*Volume 5*

**New York Power  
Authority**

**Indian Point 3  
Improved Technical Specifications (ITS)  
Conversion Package**

**Technical Specification 3.3.1:  
"Reactor Protection System (RPS) Instrumentation"**

FIGURE 3.1-1  
 Reactor Coolant System Heatup Limitations - Indian Point 3

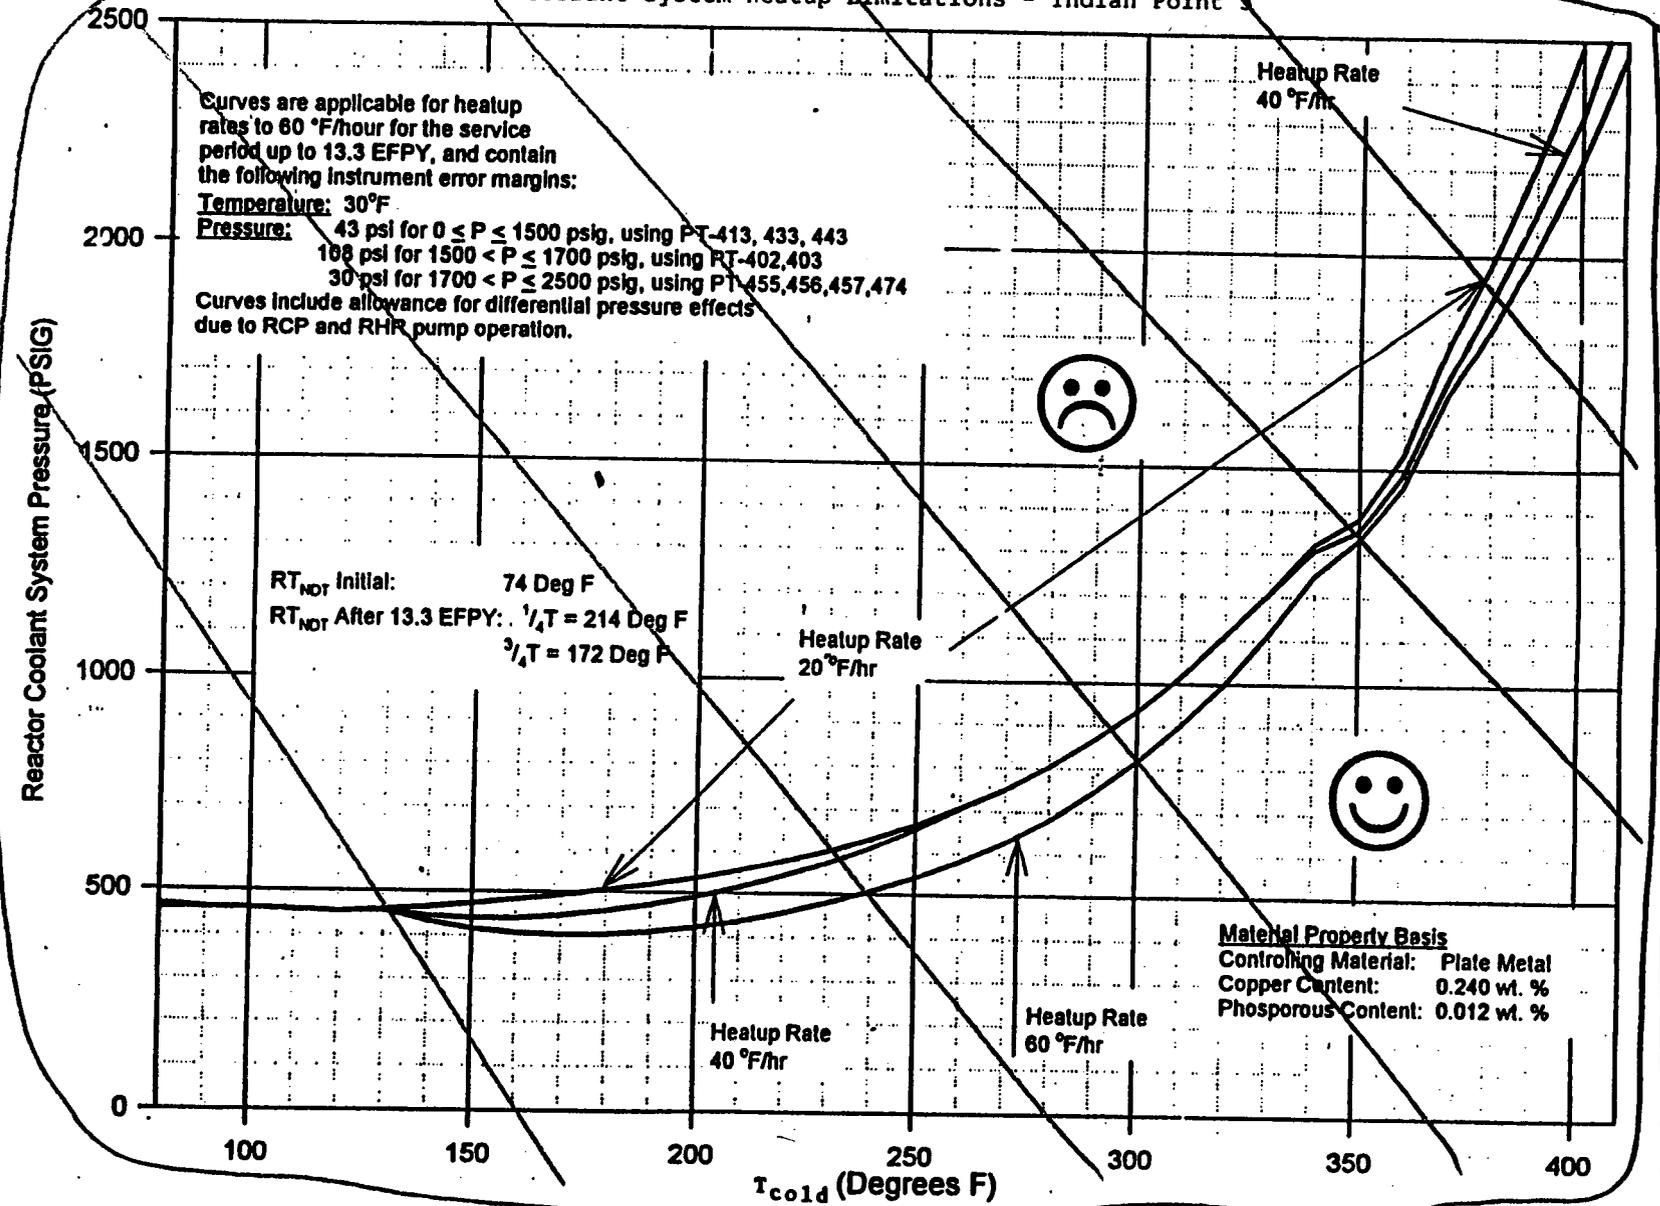
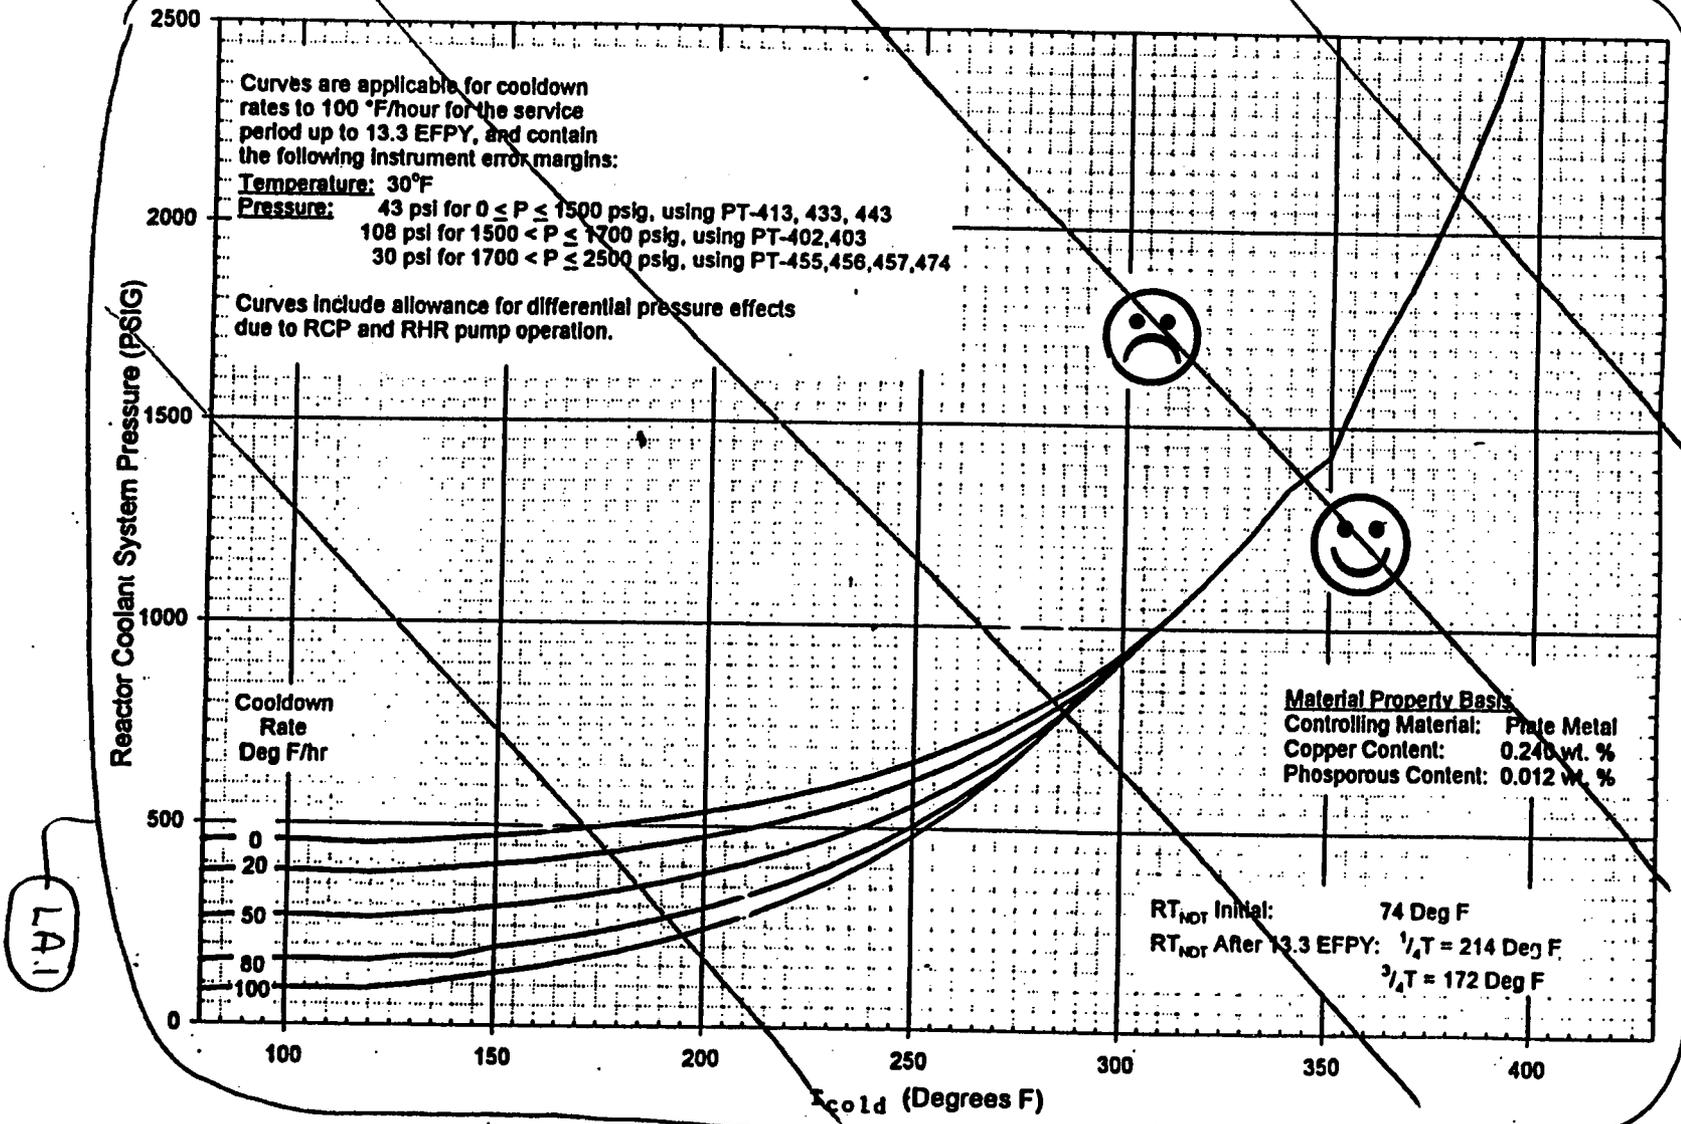
These details, including CTS Figures 3.1-1 and 3.1-2, are not retained in the ITS and are relocated to the Pressure Temperature Limits Report (PTLR) in accordance with the guidance provided in Generic Letter 96-03. This change is needed because pressure temperature limits being moved to the PTLR are revised on a periodic basis and currently requires Technical Specification changes.

FIGURE 4.3-1  
Pressure/Temperature Limits for Hydrostatic Leak Test

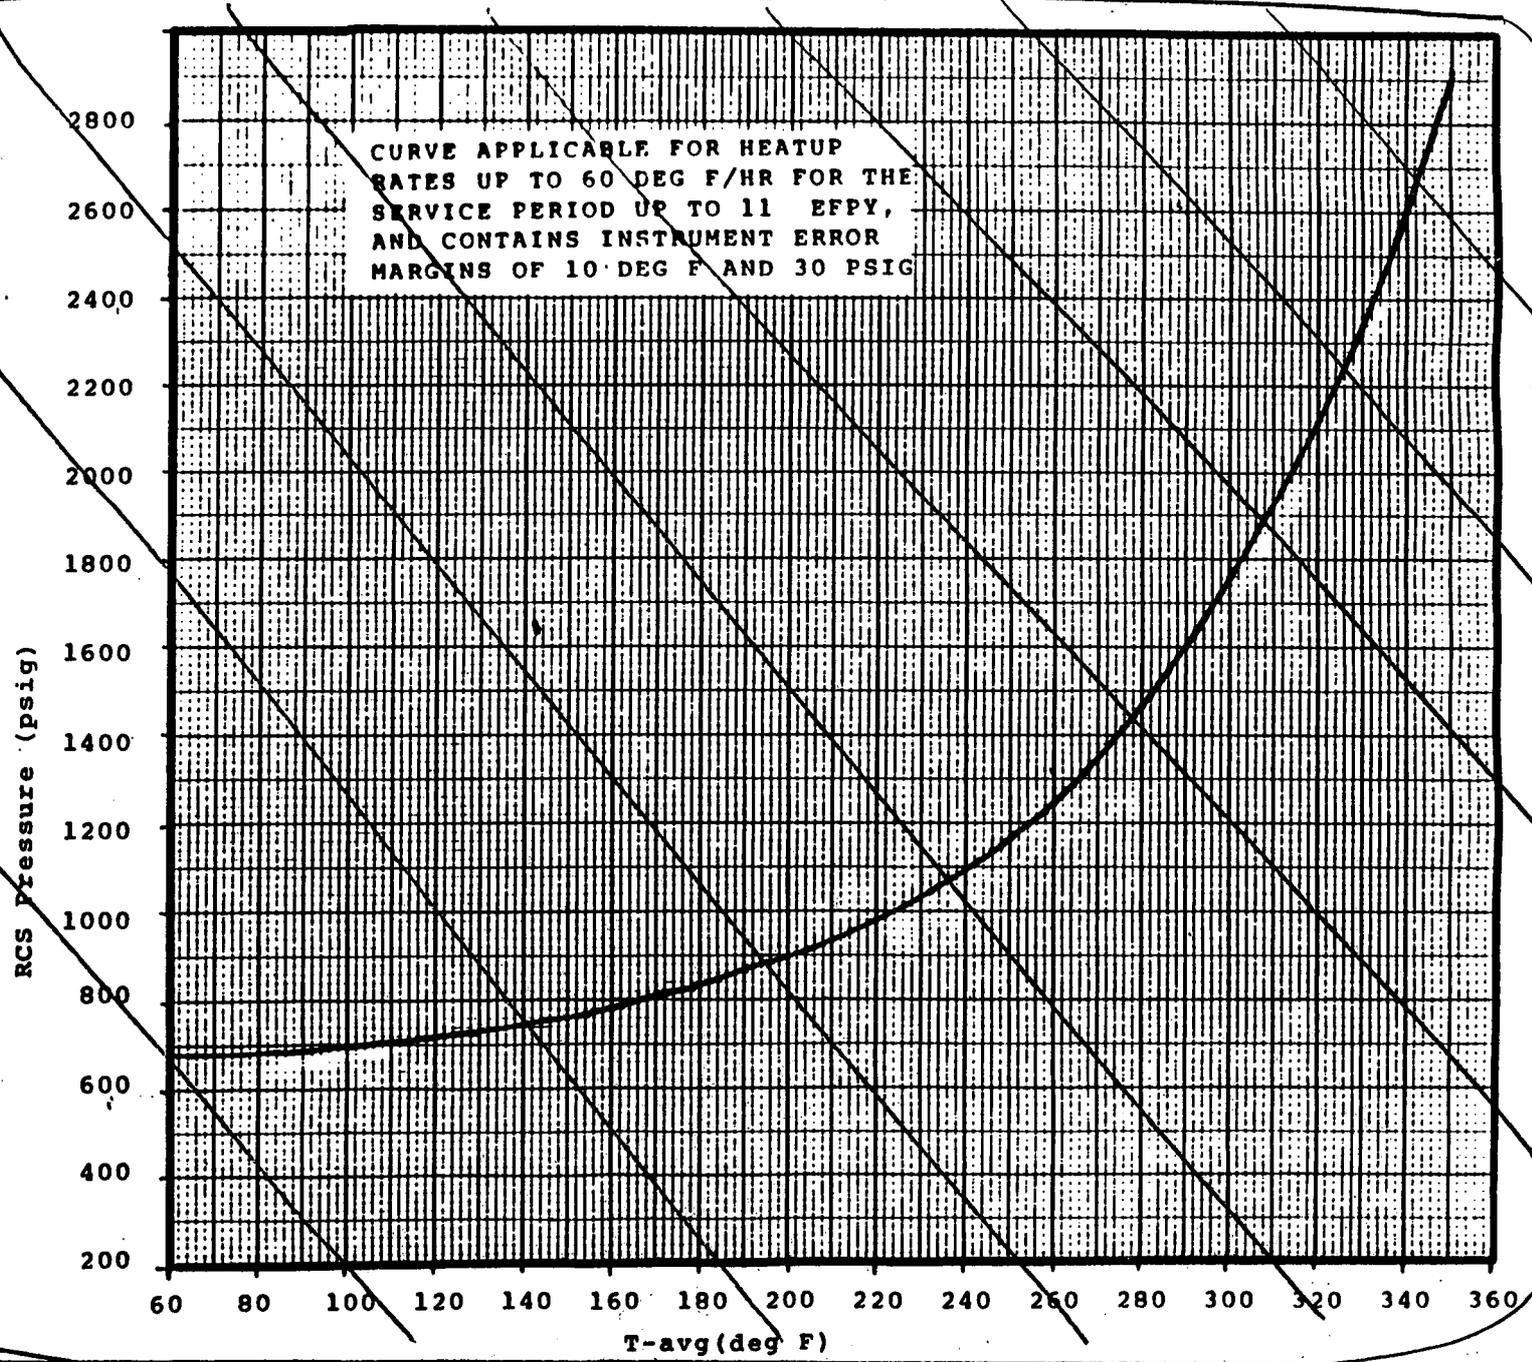
- a. specific limits for reactor coolant temperature and pressure and system heatup and cooldown rates in Figure 3.1-1 and Figure 3.1-2;
- b. pressure temperature limits during leak tests in Figure 4.3-1; an allowance that interpolation of pressure-temperature curves is permitted;
- c. the stipulation that specified values for heatup and cooldown rates are the maximum permitted values at any time;
- d. the information that Figures 3.1-1 and 3.1-2 are valid up to 11.00 effective full-power years;
- e. the information that limits must be periodically recalculated;
- f. the clarification that heatup and cooldown rates are based on the average temperature over a one hour period; and,
- g. requirements for vessel specimen removal.
